## *Kingaroy Concerned Citizens Group*

### **Response to:**

## *Cougar Energy*

Environmental Evaluations

Fig. (1) UCG Combustion Chamber. The Insert on the left is taken from Presentations (5) - (8) by Drs Cliff Mallett and Andrew Beath delivered at the Underground Coal Gasification Workshop at Kolkata, India on 12-15 November, 2006 (loc.cit. CHANDRESEKHAR, 2006)

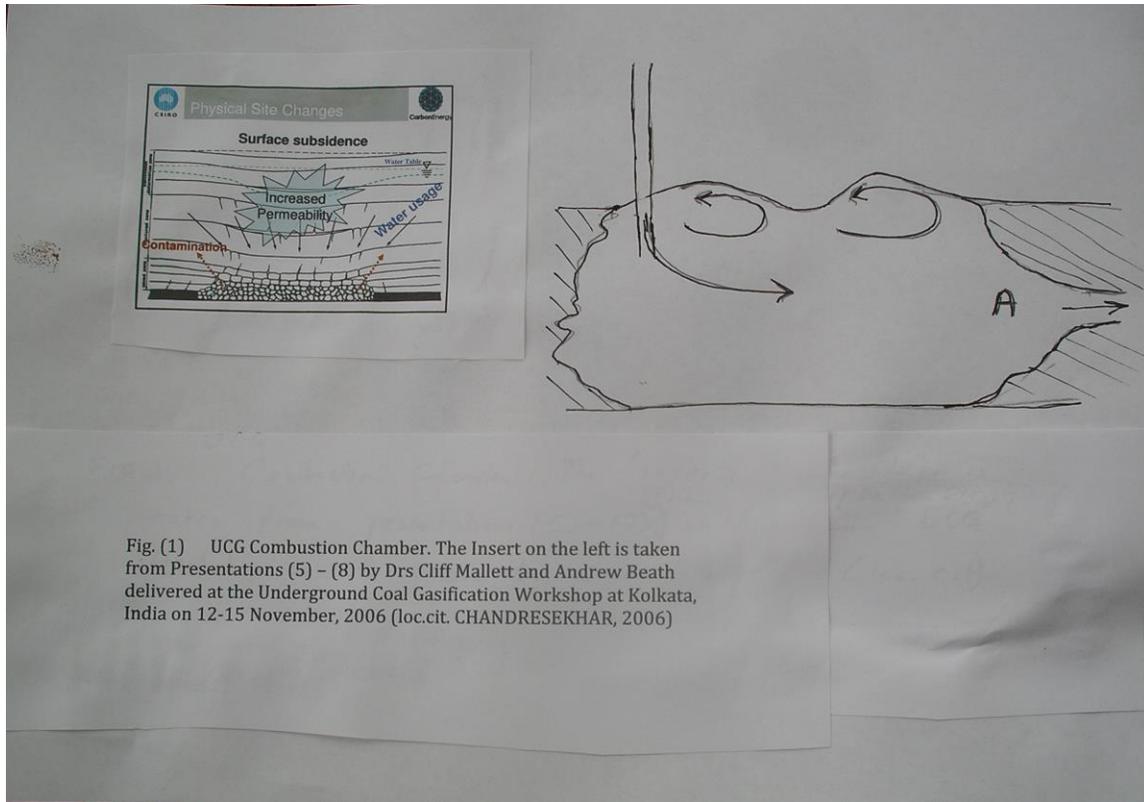
The following scenario is described for the full-scale planned Kingaroy power station ultimately intended to consume 70 million tonnes of coal. It is assumed that CRIP (directional drilling) would be used at this stage. The coal seam roof, illustrated in Fig. (1), can be expected to be undulating. If this is not its natural shape it will inevitably develop this way by spallation (rock falls). These cavities in the roof would collect relatively slow moving gas. A slow vortex gas circulation is shown in Fig (1) to illustrate the situation.

Away from the combustion front (A), the gas would be cooler with condensation of some combustion products and their solution into water seeping into the chamber. This mixture would tend initially to diffuse upwards slowly into the strata of the roof cavity because it is less dense than the adjacent surrounding water in the cavity. As it rises the 'perfect' gases (nitrogen, CO, CO<sub>2</sub>, H<sub>2</sub> etc. in the mixture will probably tend to expand, reducing the density of the two-phase fluid thus increasing the upward propulsive pressure force. The cooling effect due to vertical movement away from the cavity would tend to offset this.
